SIBLING
ARCHITECTURE

OLD BEGA HOSPITAL
ARTS & CULTURAL CENTRE

DESIGN DEVELOPMENT 03
30.04.2018

1. REVIEW OF FEEDBACK ITEMS

ADDITIONAL TOILET STRUCTURE

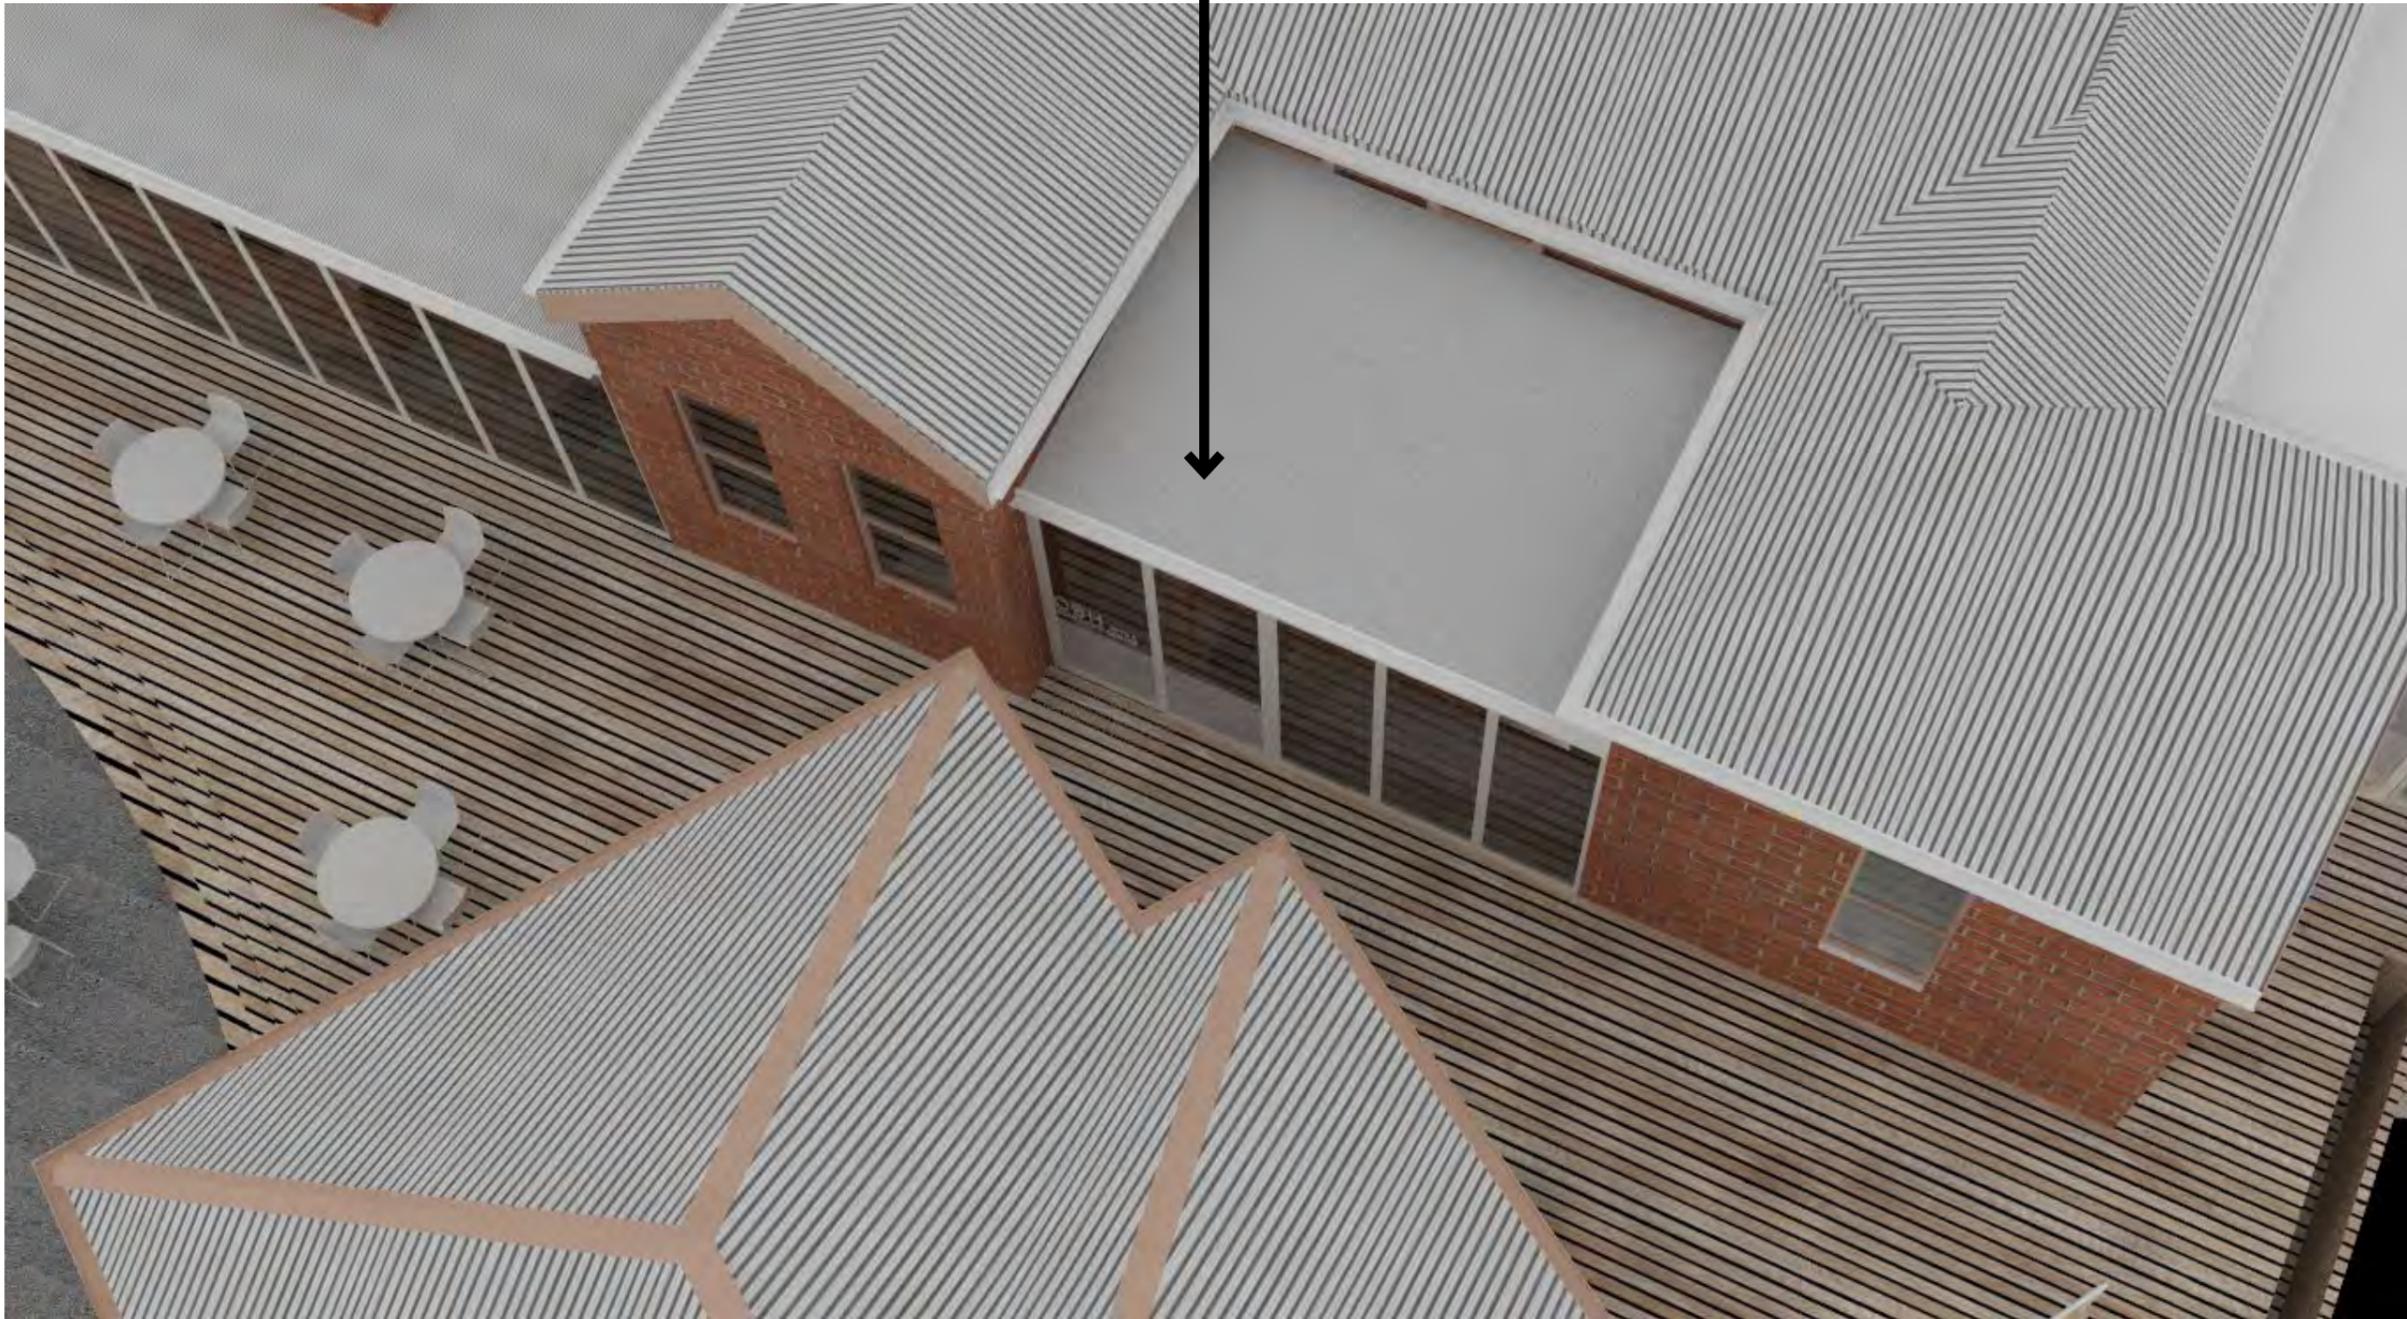
9. TOILETS: TRUST AGREES THAT THERE IS A GOOD SPREAD OF TOILETS AND THAT NUMBER WILL BE DETERMINED BY REGULATORY REQUIREMENTS. NOTE THAT THERE ARE THREE TOILETS SOUTH OF THE WOMEN'S WARD (ONE EAST OF THE PROPPED ARCH).-PLEASE SEE FOLLOWING PAGES REGARDING THIS THIRD TOILET

WE HAD ASSUMED THAT THIS WAS NOT PART OF THE ORIGINAL BUILDING AND WAS AN ADD ON FROM A LATER DATE - WHICH IS WHY WE HAD SHOWN IT REMOVED FROM THE PLANS

THE FOLLOWING PAGES SHOW BOTH OPTIONS (TO KEEP VS TO REMOVE) PLEASE ADVISE ON WHICH STRATEGY YOU WOULD LIKE TO PROCEED WITH.

UPDATED WALL TREATMENTS

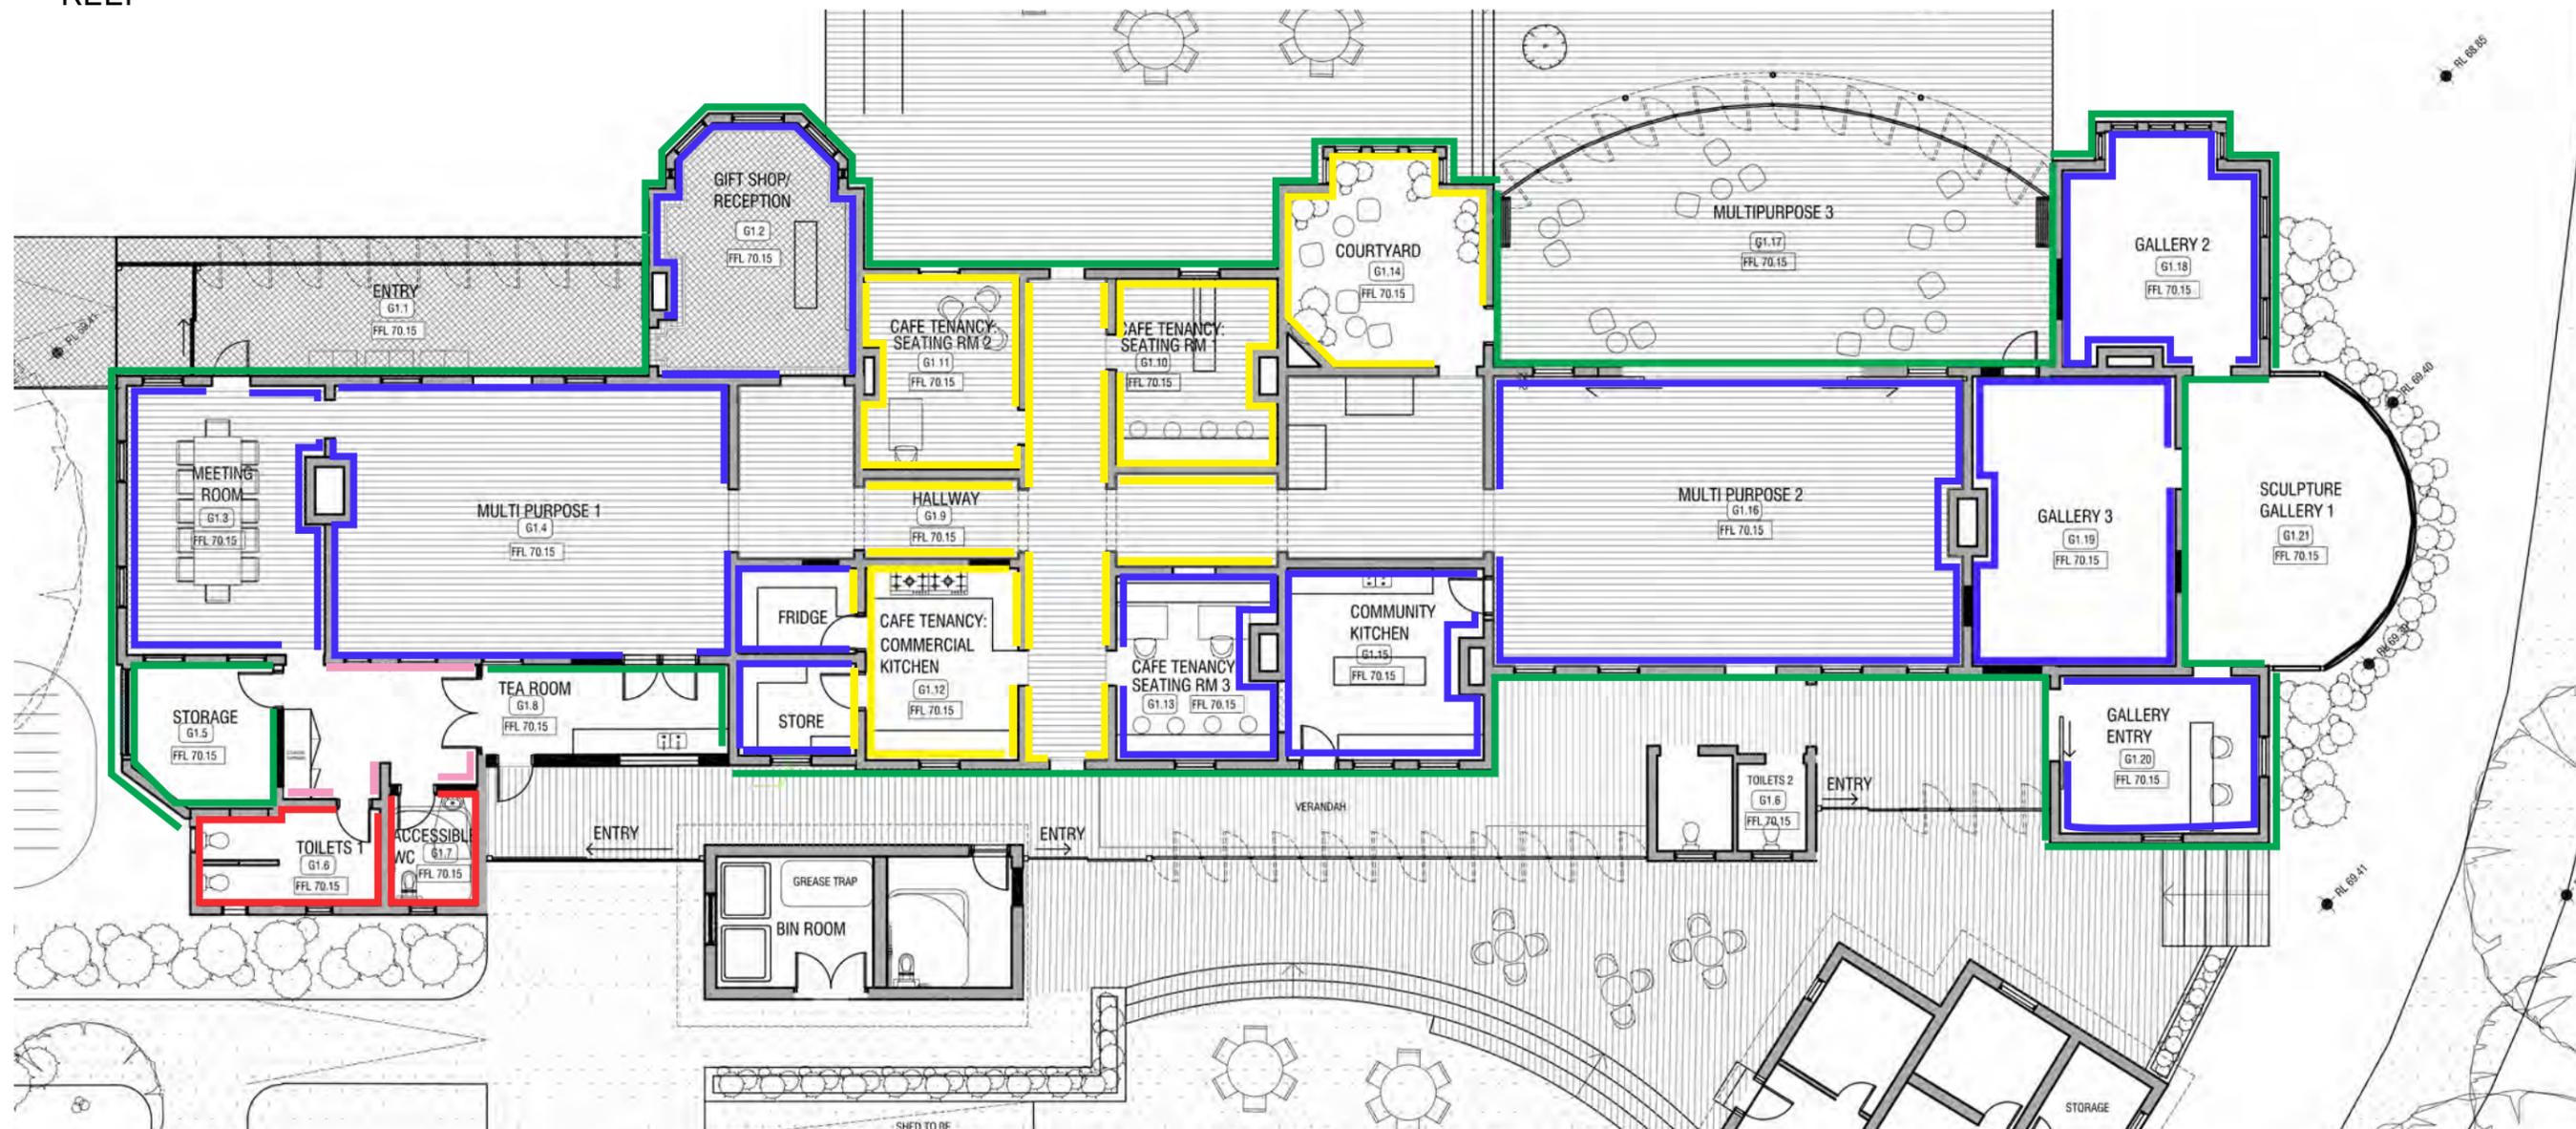
UPDATED WALL TREATMENTS AS PER TRUSTS INSTRUCTION

- RESTORE BRICK —
- REPAINT —
- RE-TILE & PAINT —
- RESTORE TILE —
- STABILIZE AND KEEP —

BATHROOM COLOURS

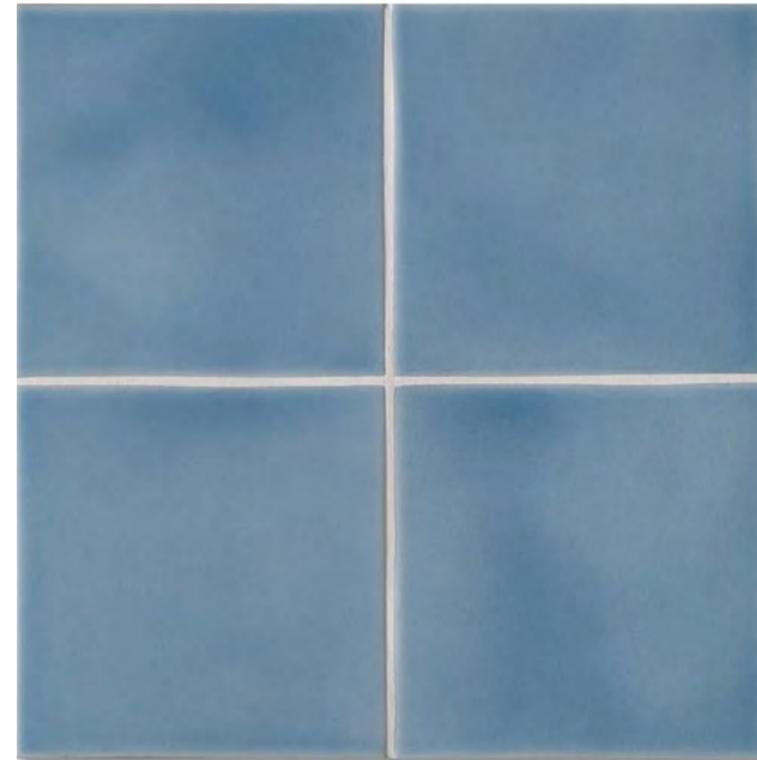
TONES OF BATHROOM TILES SHOULD REFLECT THE EXISTING COLOUR PALETTE.
